Re: Docket No. 50-275-OL
Docket No. 50-323-OL
Diablo Canyon Units 1 & 2

Your letter dated August 24, 1977 requested additional information on design criteria for structures, components, equipment, and systems included in Amendment 50.

PARTIAL RESPONSE TO NRC
LETTER OF AUGUST 24, 1977

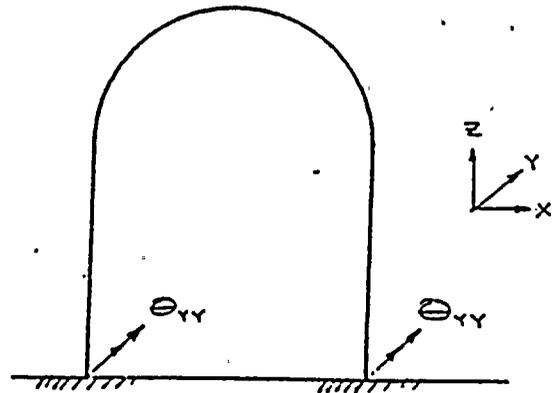
- (c) How does the fixed model as shown in Figs. 4-24 and 4-26 take account of the pin connection at the containment base?

The pin connection at the base of the Containment was accounted for by releasing the rotational degree of freedom θ_{yy} (see figure) at the base of the axisymmetric model.

Fig 1 Response Due to E-W
Component of Ground Motion

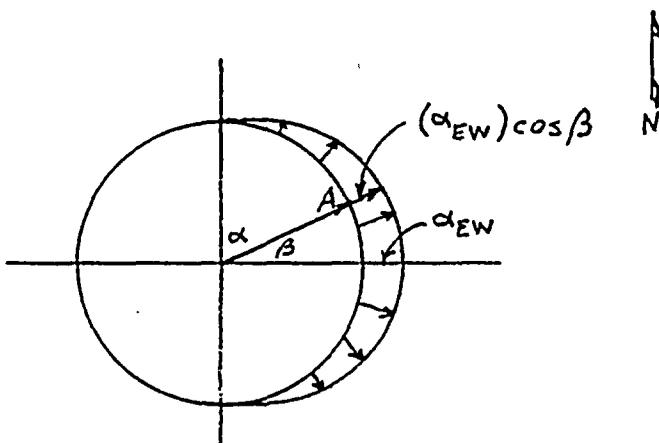
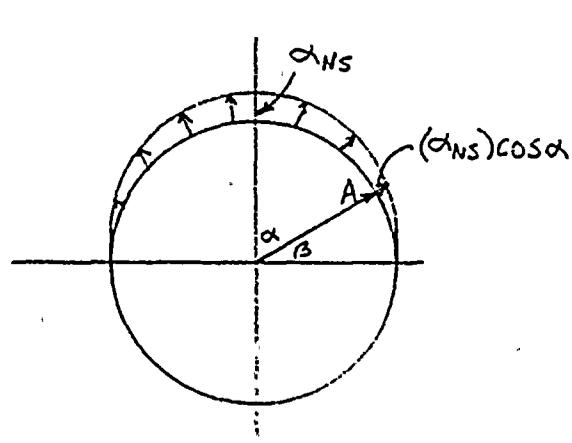
On Page 4-15, the last paragraph refers to the combination of effects due to horizontal input motions. It is not clear that in all cases the horizontal motion effects are due entirely to one direction of motion. For example, the maximum vertical stress due to motion in one direction may occur at the same time as the maximum shear due to motion at right angles to that direction. Please explain.

In an axisymmetric shell each component of the ground motion will produce 3 sets of responses at a given point in the structure (radial, tangential, and longitudinal). The SRSS combination of similar responses due to different components of ground motion gives the sum of the three radial responses at a point due to the three components of ground motion. Therefore, maximum vertical and shear stresses are not combined in the results shown in Tables 4-9 and 4-10.

The last paragraph on Page 4-15 explains that the horizontal responses at a given elevation due to the horizontal components of ground motion vary as a cosine function, as shown in Figures 1 and 2 below. As an example, consider the absolute radial accelerations. Let α_{N-S} be the absolute radial acceleration response due to the N-S component of ground motion, and let α_{E-W} be that due to the orthogonal component. The distribution of these accelerations is shown in Figures 1 and 2. The SRSS combination of the radial acceleration (α_{radial}^H) at any point A due to these components of ground motion is:

FIG. 4 - 164

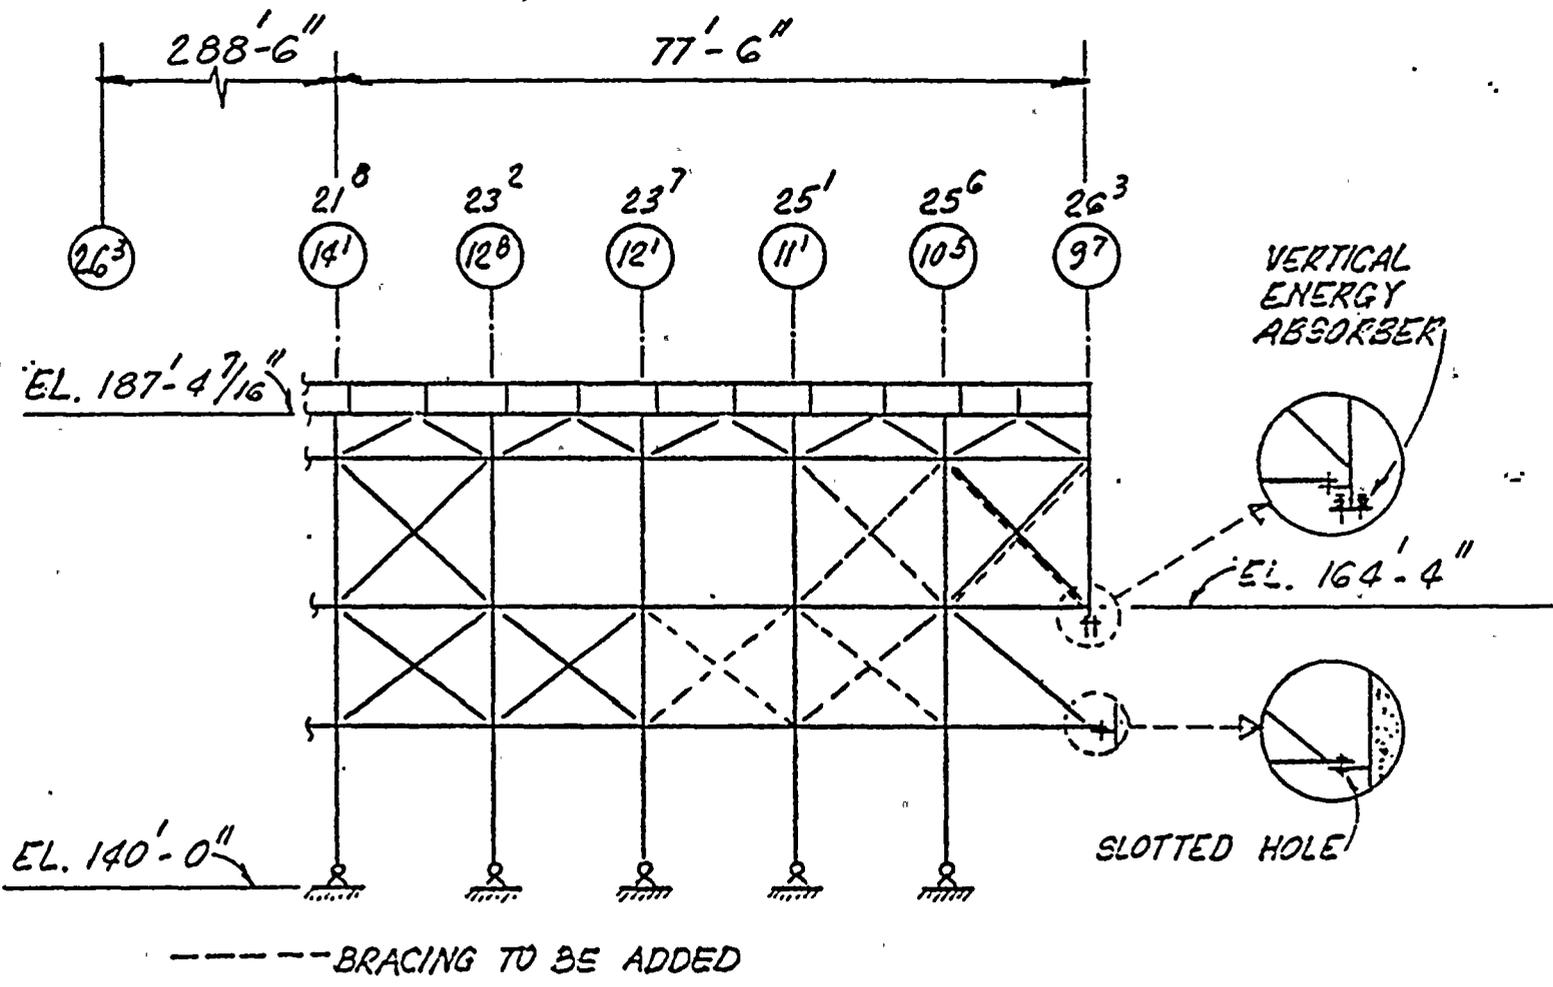
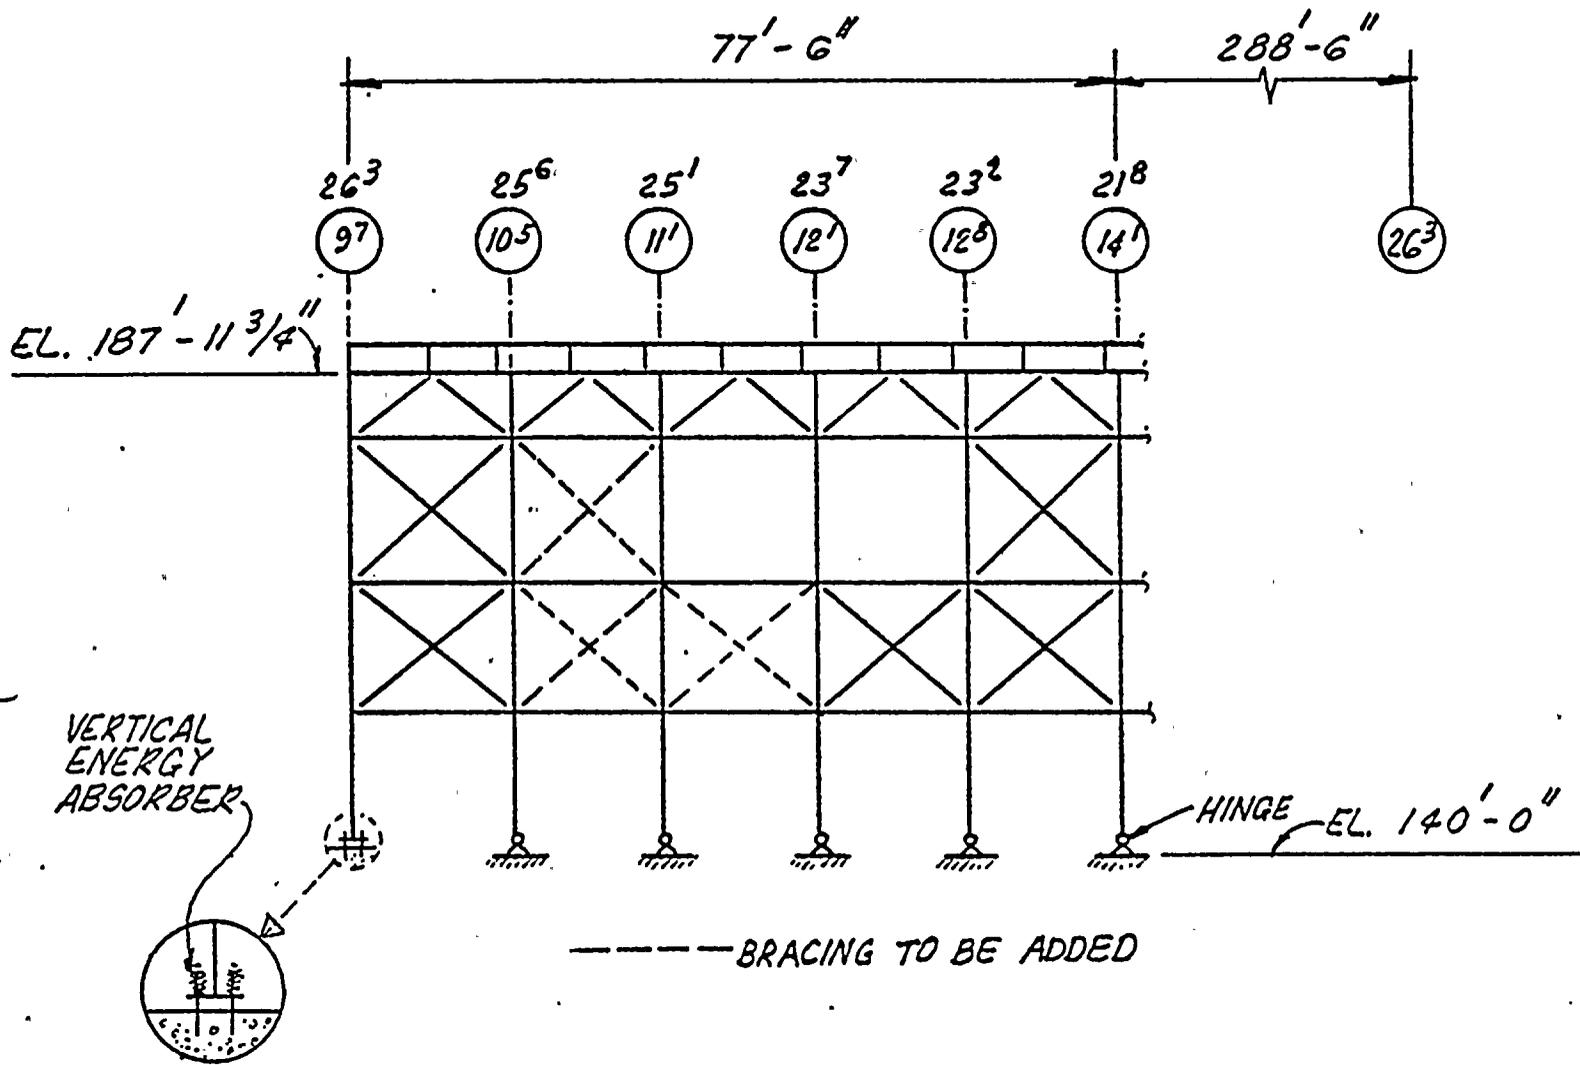
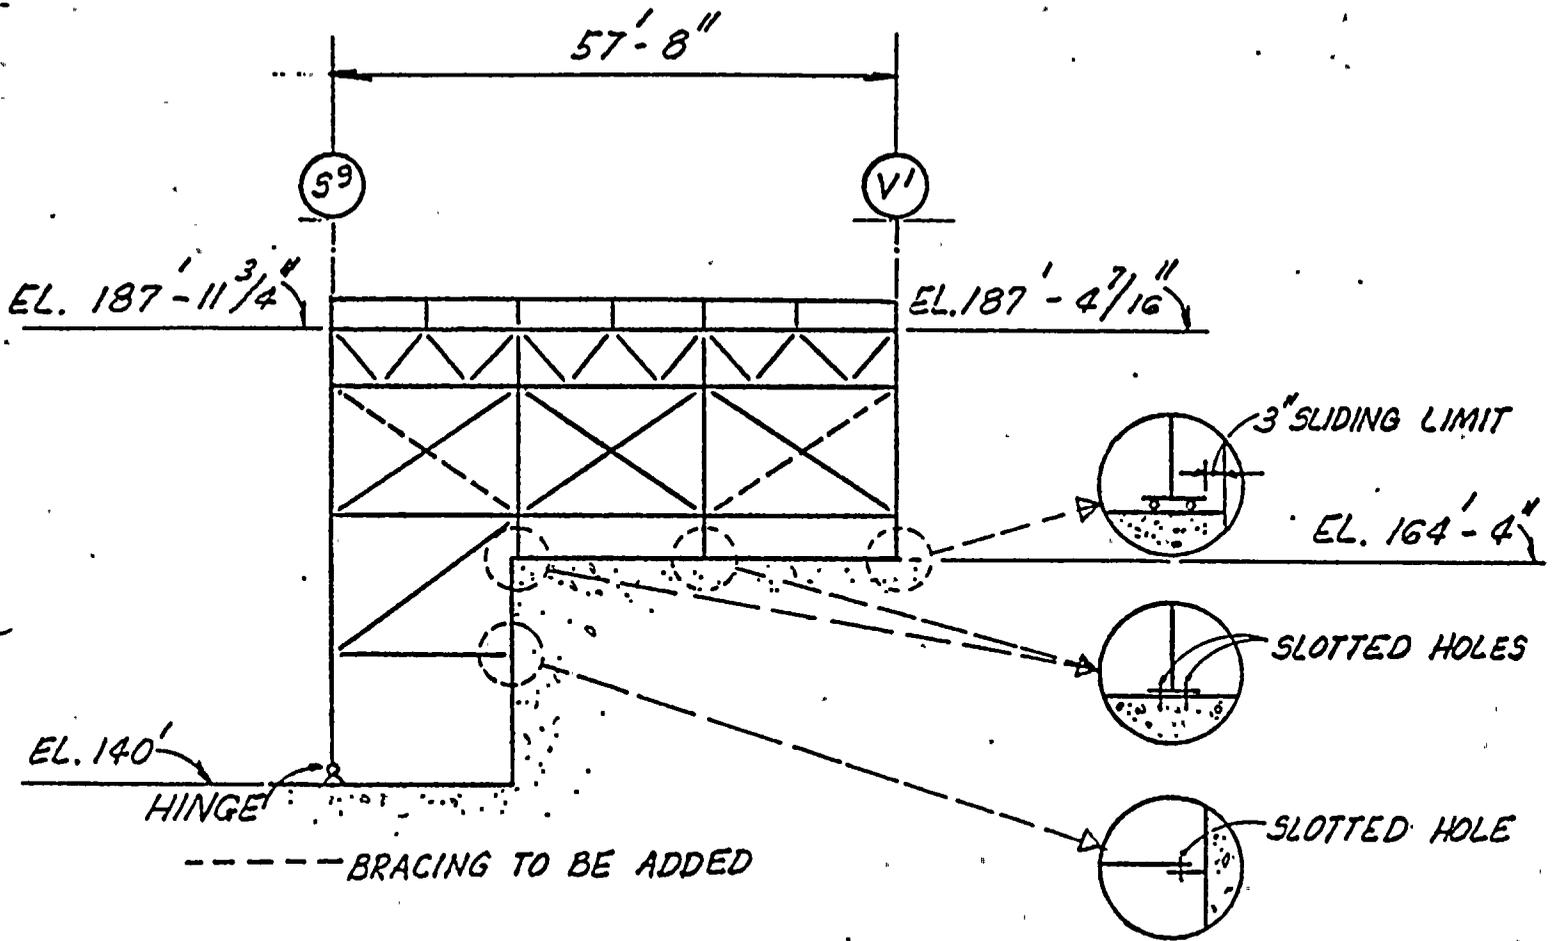
The details of the fuel-handling crane support structure referred to on Page 4-36 are not included. Please provide.

Specific modifications for the fuel handling area are presented in Figures 4-164 through 4-166. Partial release of the supports shown in Figure 4-166 enables the structure to deflect uniformly throughout its entire length under earthquake loads in the E-W direction; hence the seismic loads will be evenly distributed to all column anchorages, rather than being taken primarily by the anchor bolts of the end bents. Also, the torsional stresses introduced previously by the rigid condition of the end bents will be reduced considerably. The release of the supports shown in Figures 4-164 and 4-165 provides, for the N-S direction, the same solution as described above. The added bracing eliminates uneven distribution of the pullout forces on the column anchorages. As a result of these modifications, critical stresses in the anchorages will be less than allowable.
